## TECHNICAL SERVICE BULLETIN

### 4WD - 6R100 - Metallic Grinding Noise Under Light Acceleration Between 23-33 MPH (37-53 Km/H) - Built On 01-Feb-2021 And Through 16-May-2022

22-2199

17 May 2022

Figure 1

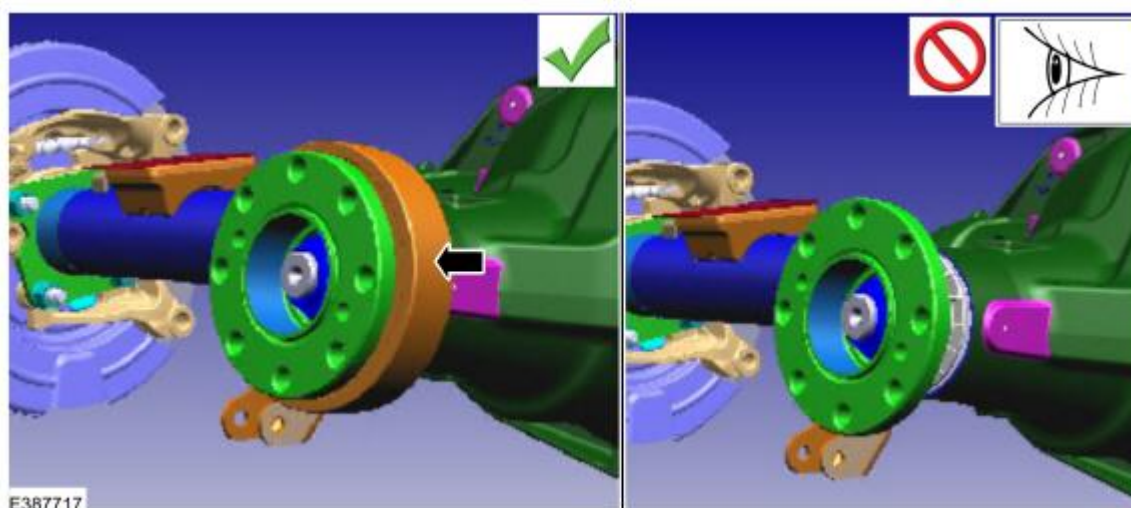
1. Inspect the rear axle pinion flange for the presence of a sound damper. Is a damper present? (Figure 1)

- (1). Yes - proceed to Step 2.
- (2). No - replace the rear axle pinion flange and rear pinion seal. Refer to Workshop Manual (WSM), Section 205-02.
